# VALUE ENGINEERING REPORT

I-575 @ Ridgewalk Parkway  
Project No. CSNHS-0006-00(043)  
PI No. 0006043  
Cherokee County

November 19, 2008

MACTEC Engineering and Consulting, Inc.  
3200 Town Point Drive NW, Suite 100  
Kennesaw, GA 30144

<b>IDEA No.:</b> A-3	<b>Sheet No.:</b> 1 of 4	<b>CREATIVE IDEA:</b> Adjust the Ridgewalk Parkway typical section between the Interchange Ramp intersections (match dual bridges).
-------------------------	-----------------------------	--

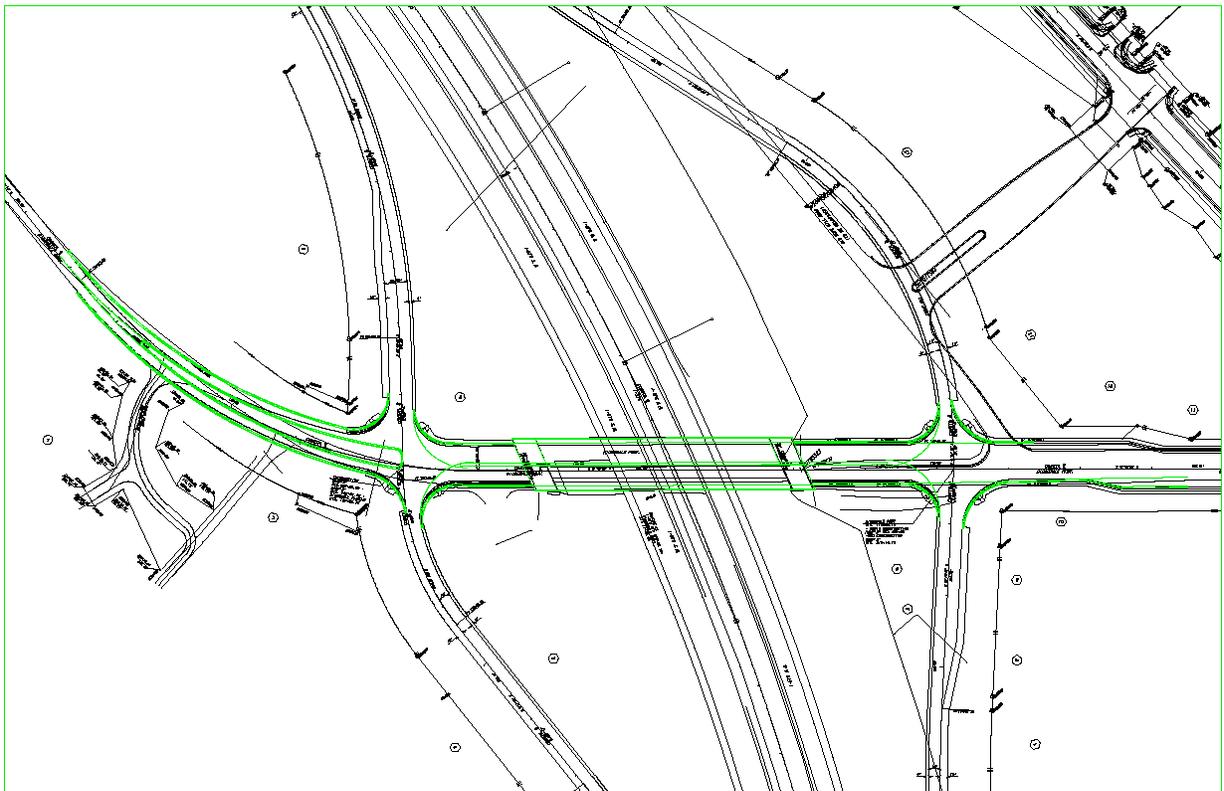
The current roadway typical section matches the proposed typical section for the combined new / old bridge typical section. The proposed bridge typical section provides dual 10-foot sidewalks, dual 6-foot shoulders, two 12-foot travel lanes, and an 18-foot median. The roadway section changes as it approaches the ramp intersections where left-turn lanes are provided in the median.

It is recommended that the roadway typical section (between the Interchange ramp intersections) be change to a four-lane roadway to match the VE recommended new bridge typical section. Under the VE proposal, the new bridge typical section will be two 5 1/2 –foot sidewalks, two 2-foot shoulders on both sides of the longitudinal joint, a 4-foot raised median, and four 12-foot travel lanes.

The roadway typical section must be adjusted to match the typical section on the new combined bridge. Under all bridge scenarios, there appears to be adequate room for a four-lane roadway.

<b>IDEA No.:</b> A-4	<b>Sheet No.:</b> 1 of 4	<b>CREATIVE IDEA:</b> Evaluate the relocated Old Rope Mill Road typical section.
-------------------------	-----------------------------	---

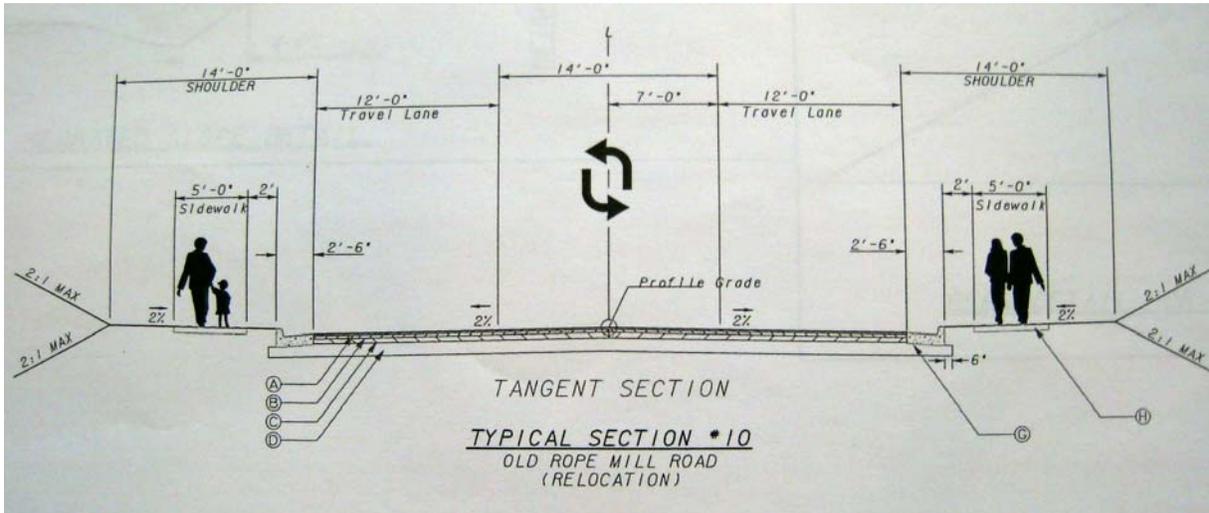
The existing concept relocates Old Rope Mill Road to begin north of the existing Ridgewalk Parkway / Woodstock Parkway intersection and extend 2,950 feet to tie in to the existing old roadway just south of the existing park. The proposed roadway cross section includes two 12-foot travel lanes, a 14-foot center turn lane, and curb and gutter with 14-foot shoulders (including 5 foot sidewalks) on each side.

It is recommended that the center left turn lane be provided only at the Ridgewalk Parkway intersection and that it be deleted from the remainder of the side road's length.

Existing Old Rope Mill Road is a two lane paved roadway providing access to the small local park at the Little River. The road is a dead end road. Facilities at the park include a parking area and small pavilion. The road also provides access to a commercial building. The existing road includes curb and gutter on one side, with no sidewalks. The commercial building has an access road in front of it with curb and gutter and sidewalks on both sides of the road. Since the road will never be lengthened and there will be limited opportunity for opposing traffic to block left turn movements, we recommend deleting the center turn lane.

<b>IDEA No.:</b> A-4A	<b>Sheet No.:</b> 1 of 4	<b>CREATIVE IDEA:</b> Reduce the urban shoulder width from 14 feet to 12 feet on relocated Old Rope Mill Road.
--------------------------	-----------------------------	---

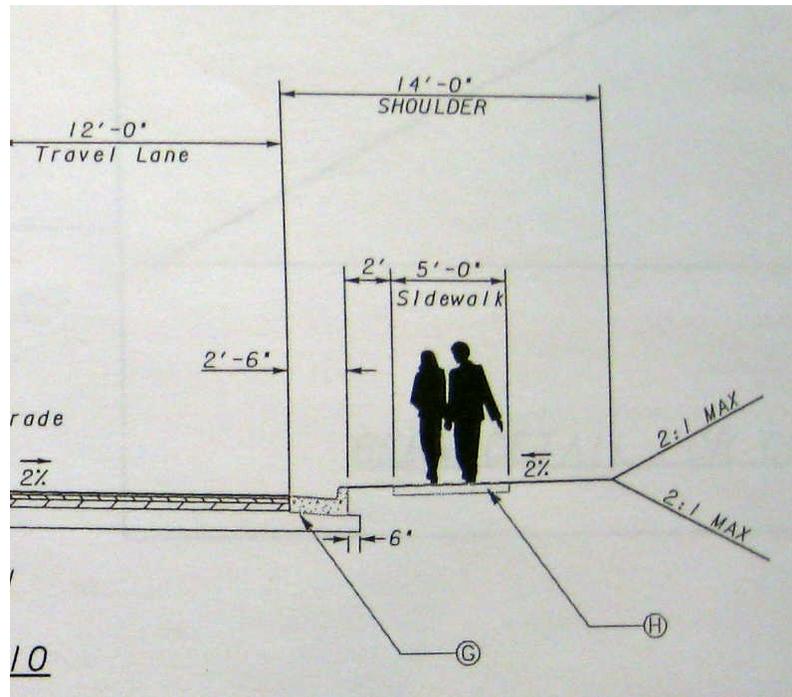
The existing concept relocates Old Rope Mill Road to begin north of the existing Ridgewalk Parkway / Woodstock Parkway intersection and extend 2,950 feet to tie in to the existing old roadway just south of the existing park. The proposed roadway cross section includes two 12-foot travel lanes, a 14-foot center turn lane, and curb and gutter with 14-foot shoulders (including 5 foot sidewalks) on each side.

It is recommended that the 14-foot shoulder width be reduced to 12 feet.

Reducing the shoulder width from 14 feet to 12 feet would reduce the amount of R/W required to construct the project. A 12-foot wide shoulder would provide sufficient space for a sidewalk and open area between the sidewalk and curb and gutter section.

<b>IDEA No.:</b> B-3	<b>Sheet No.:</b> 1 of 4	<b>CREATIVE IDEA:</b> Eliminate the MSE wall(s) on relocated Old Rope Mill Road.
-------------------------	-----------------------------	---

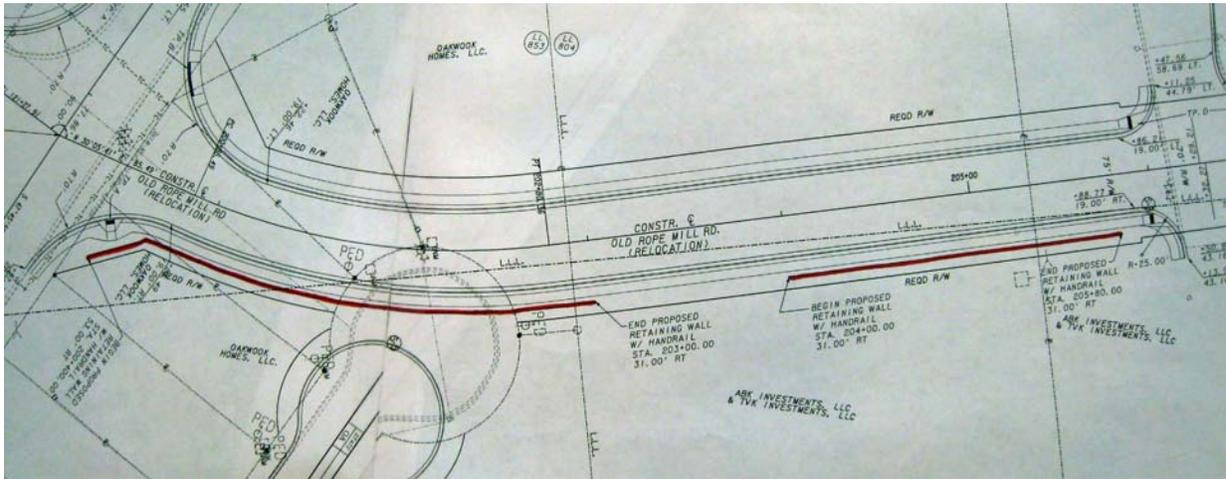
The original design provides for a narrow roadway embankment by constructing MSE walls on Relocated Old Rope Mill Road just north of Ridgewalk Parkway.

It is recommended that the MSE walls be eliminated and that additional R/W be acquired to provide sufficient room to widen the embankment and construct standard cut/fill slopes.

The relocation of Old Rope Mill Road will be constructed in an entirely new location and R/W will have to be acquired. The purchase of the small amount of additional R/W and extra embankment would cost less than the cost of the MSE retaining walls.

### **COST ESTIMATE NOTE:**

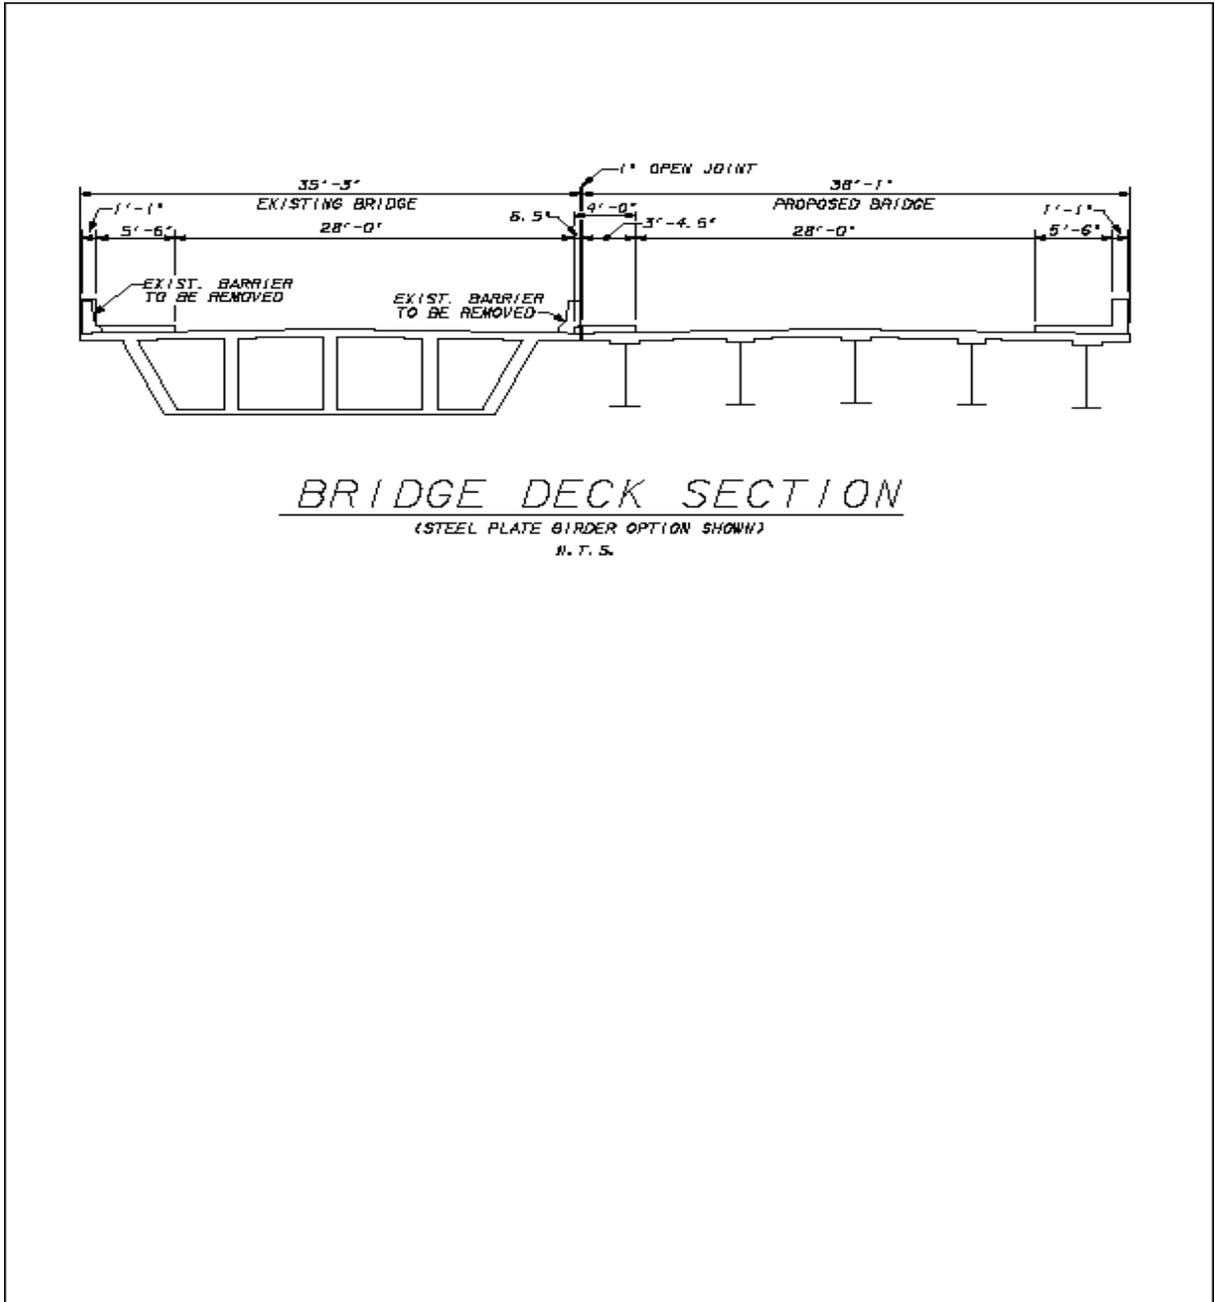
The VE team believes the estimated \$114.09 / SF unit price to construct the proposed 328-foot post tensioned concrete box bridge over an active Interstate is extremely low. There will be significant constructability concerns with this type of structure. The DOT bridge design office could not provide the team with any recent unit prices for similar structures. Due to the extensive false work needed to construct the concrete box bridge and the extra time needed for its construction, a more reasonable unit price estimate should be between \$150 and \$200 /SF.

Using the same \$140.00 / SF unit price for a similar length plate girder bridge would raise the cost of the concrete box bridge by \$365,000. **This \$365,000 additional cost would be additive to the net savings found on the first page of this recommendation resulting in a potential savings of \$864,000.**

### **COST ESTIMATE NOTE:**

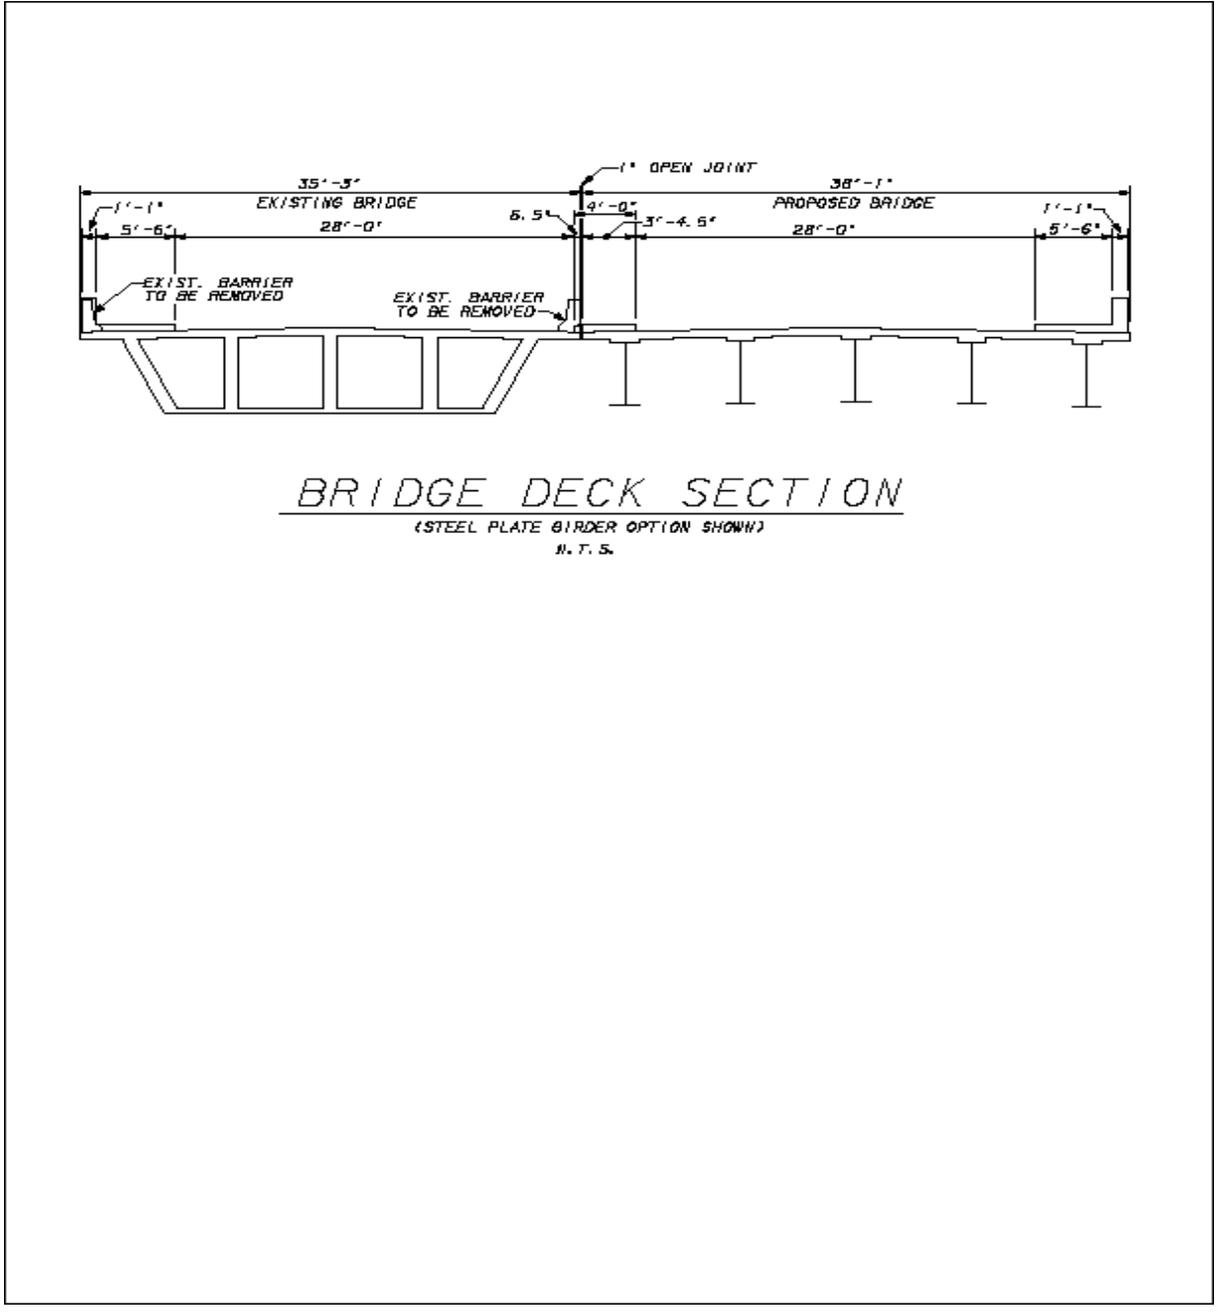
The VE team believes the estimated \$114.09 / SF unit price to construct the proposed 328-foot post tensioned concrete box bridge over an active Interstate is extremely low. There will be significant constructability concerns with this type of structure. The State bridge section could not provide the team with any recent unit prices for similar structures. Due to the extensive false work needed to construct the concrete box bridge and the extra time needed for its construction, a more reasonable unit price estimate should be between \$150 and \$200 /SF.

Using the same \$140.00 / SF unit price for a similar length plate girder bridge would raise the cost of the concrete box bridge by \$365,000. **This \$365,000 additional cost would be additive to the net savings found on the first page of this recommendation resulting in a potential savings of \$109,000.**
